## Technical change to M12 crimp connector with crimp flange

the products of the M12 crimp connectors with crimp flange will be changed with immediate effect.  
Please forward this Product Change Notice (PCN) to your employees and, if applicable, to your customers.

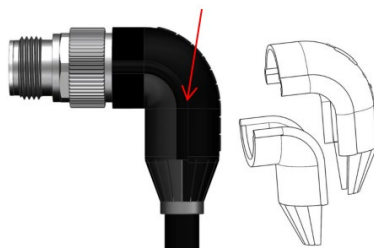
All M12 crimp connectors with crimp flange are supplied with the contacts and the grommet.  
Over time, the market has reflected to us that the grommet is very rarely needed or the contacts in a different number. These will be offered separately from now on.

In addition, we will adapt the outer packaging.  
From now on, all connectors will no longer be additionally packed in an outer carton.

For all M12 crimp connectors with crimp flange, the contacts and the grommet are omitted from the scope of delivery and can then be ordered separately.
